Model: MZ-E3

No. 511

Subject: Display Only, No Operation

Date: January 30, 1997

FIG.1

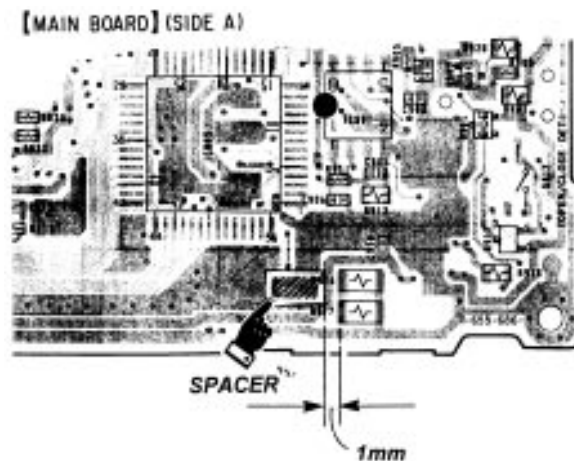
(112) Unit powers up but sled can not move

- I. Replace the sled motor
- II. Replace the inductors with those identified in the table
- III. Add spacer as shown in Fig 1.

REF	FORMER		NEW	
	DESCRIPTION	PART NUMBER	DESCRIPTION	PART NUMBER
M902	SLED MOTOR	1-698-315-11		
L503, 507, 509 515, 516 801	INDUCTOR 47H	1-414-402-11		1-412-031-11
ADD			SPACER (3X3)	4-984-119-01
